AMENDMENT NO. 1 JULY 1983
TO
IS : 1361-1978 SPECIFICATION FOR STEEL
WINDOWS FOR INDUSTRIAL BUILDINGS

(*First Revision*)

FIG. 3 SECTIONAL DETAILS THROUGH SASHES

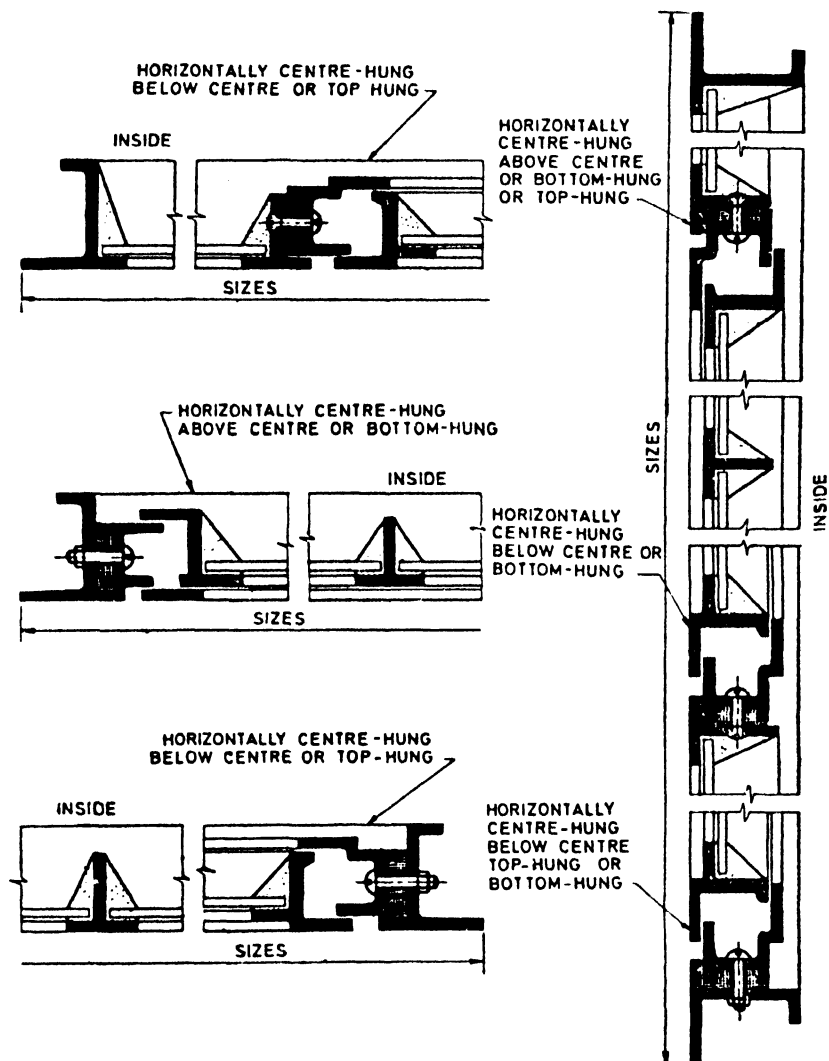
(Page 10, Fig. 3) — Substitute the following for the existing figure:

FIG. 5 SPRING CATCH, PULLEY AND CORD-EYE

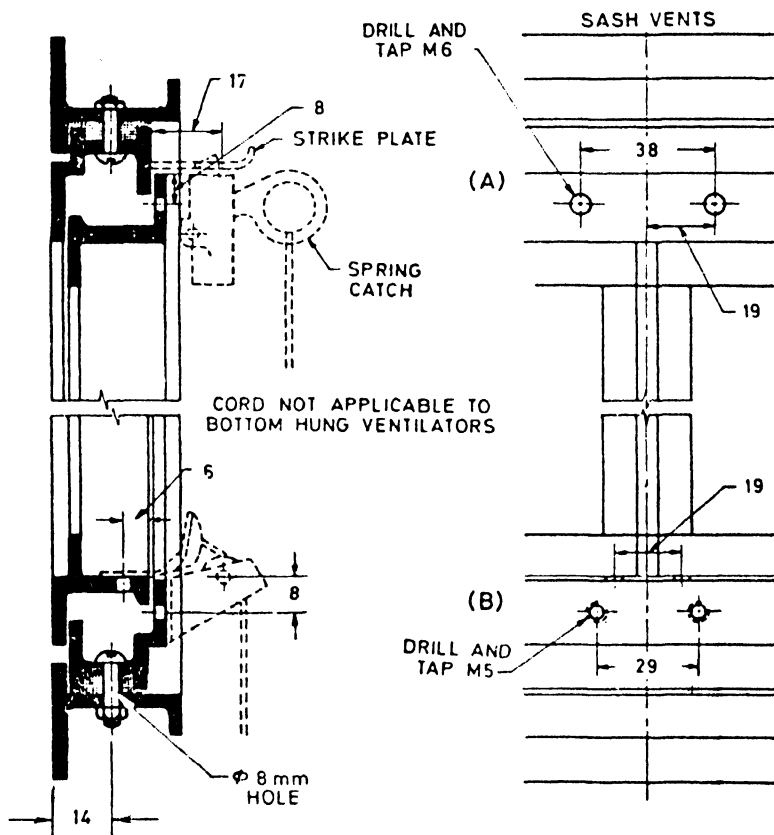
(Page 13, Fig. 5) — Substitute the following for the existing figure:

- (A) Preparation for spring catch on horizontally pivoted and bottom hung ventilators
(B) Preparation for pulley and cord-eye on horizontally pivoted ventilators

NOTE — Mastic should be applied to joints where hatching shown.
